TRINITY SITE D - CONDITION 142 - BAFFLES

REV	PURPOSE OF ISSUE	DATE	AUTHOR
REV (-)	FIRST ISSUE	08/04/2026	KATY HAYHOE

CONTEXT - PLANNING PROPOSALS (2021)

BAFFLE PROPOSALS AT PLANNING

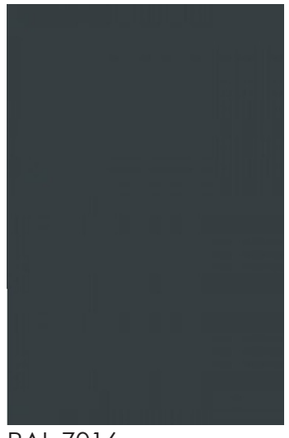
The plan opposite shows the wind baffle measures proposed as part of the 2021 planning application. The measures were part of a detailed wind study under taken by WSP Wind Consultants and coordinated with the wider design team.

A range of baffle types were proposed and when in close proximity to the building the height was proposed to align with the top of balustrade height at level 1. The RAL colour is 7016 to match the architectural metalwork (balustrade / terrace cill details).

Baffles within the public realm were proposed at 1.5, 3 and 3.5m in height.

A series of the taller baffles span the landscape between Tower D1 and Tower D2 and create a visual and physical structure that creates a transition from the car park and service yard areas. The structures create a focal to the gardens / parkland beyond.

DESIGN PROPOSALS - BAFFLE LOCATION & DRAWING REFERENCE PLAN

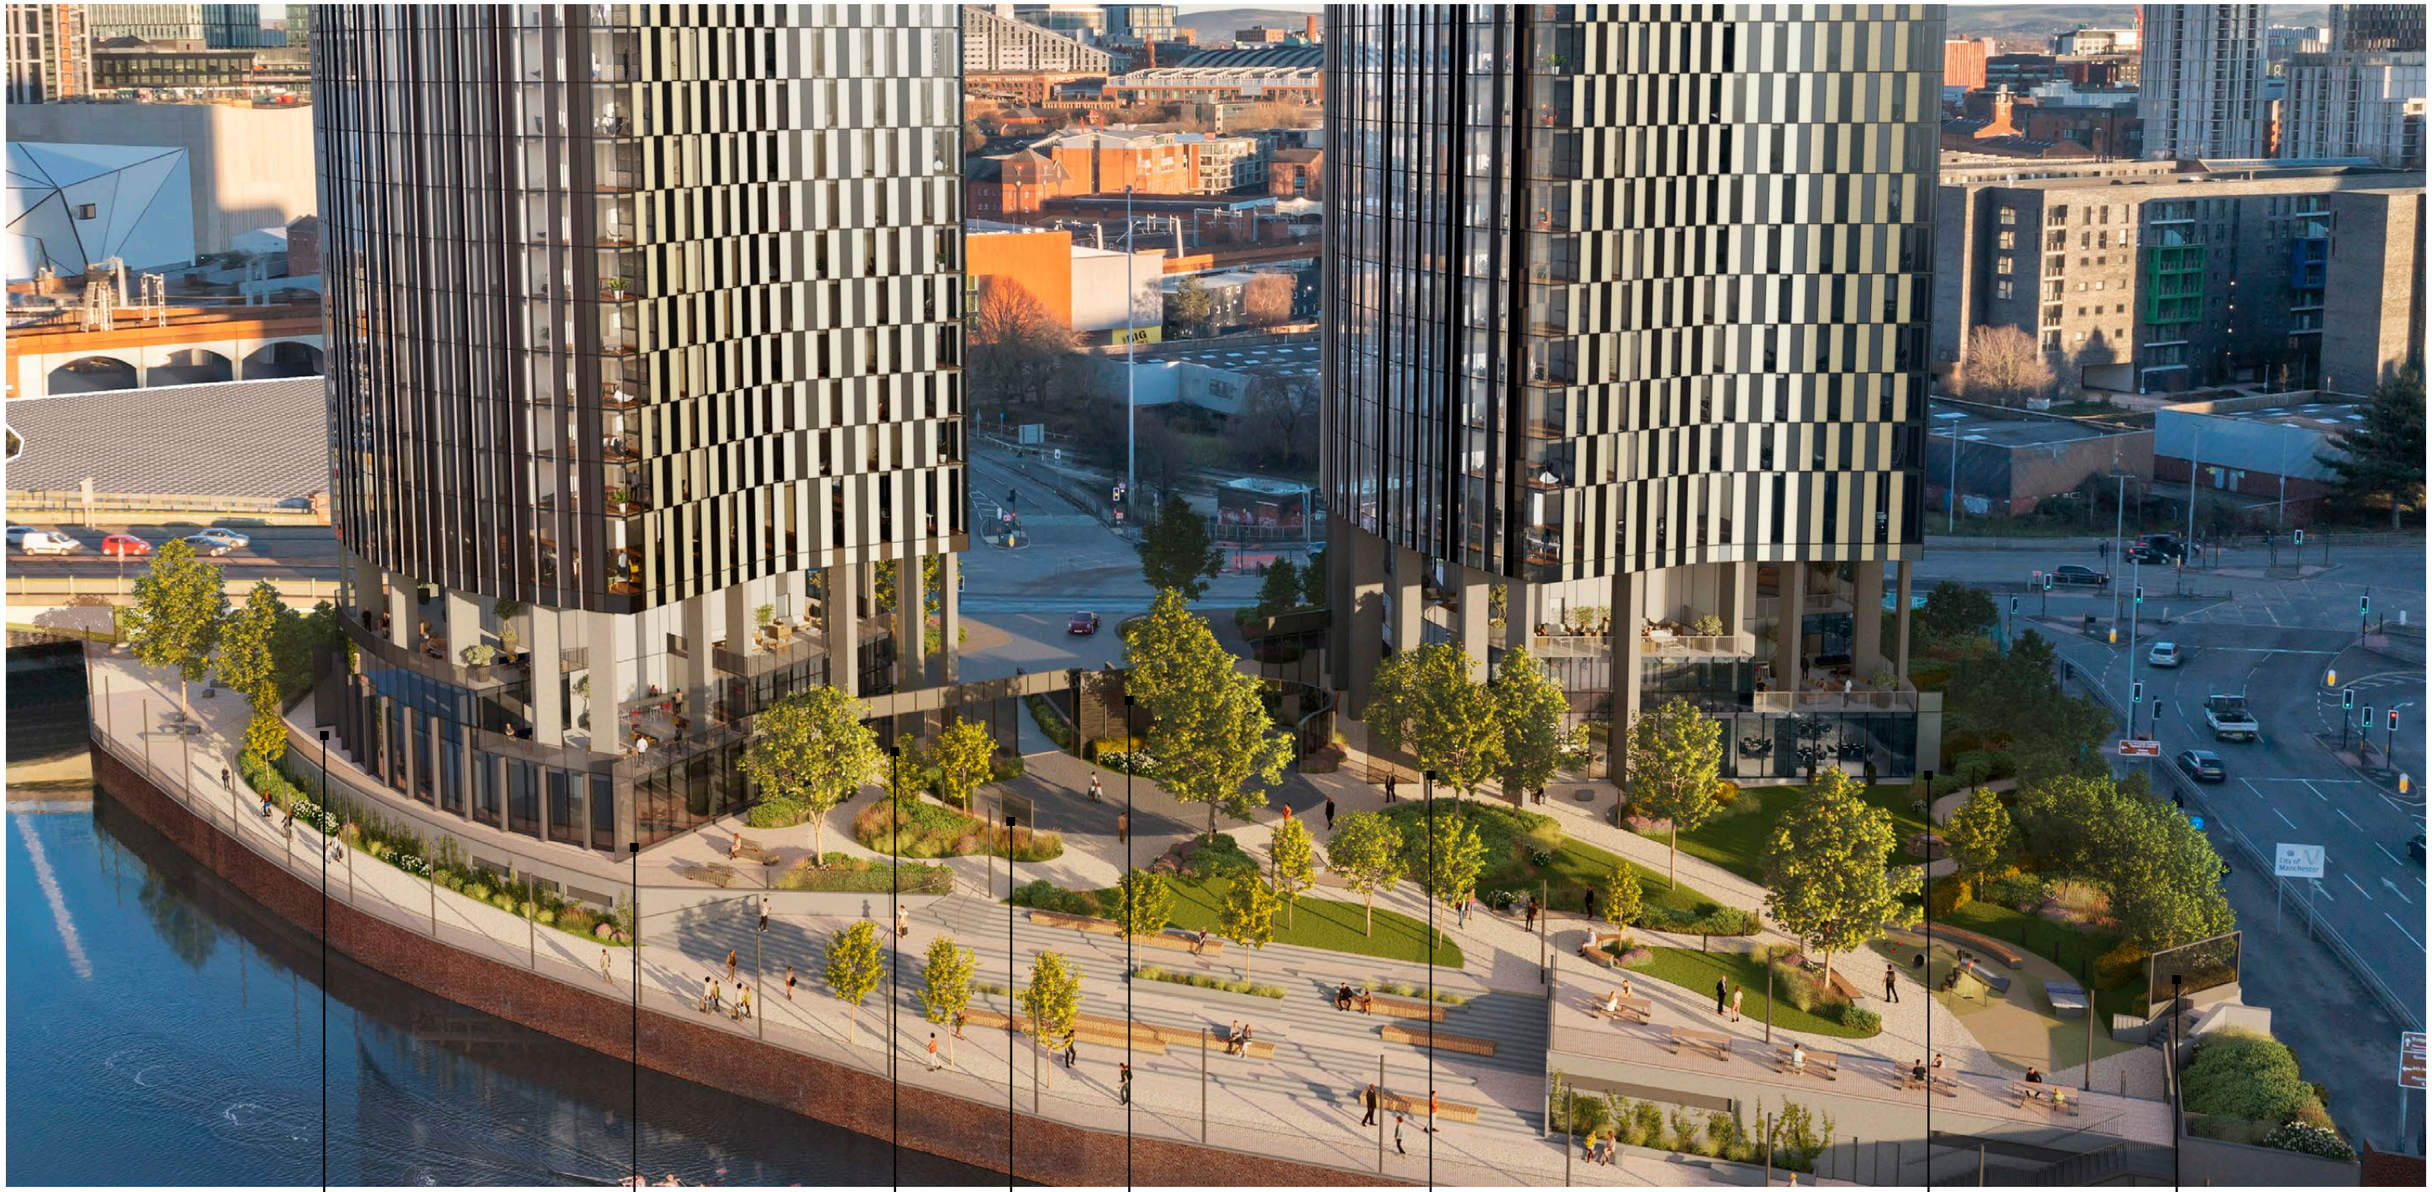
NB - The baffle drawings references noted below have been submitted previously to MCC under Conditions 112 and 156.
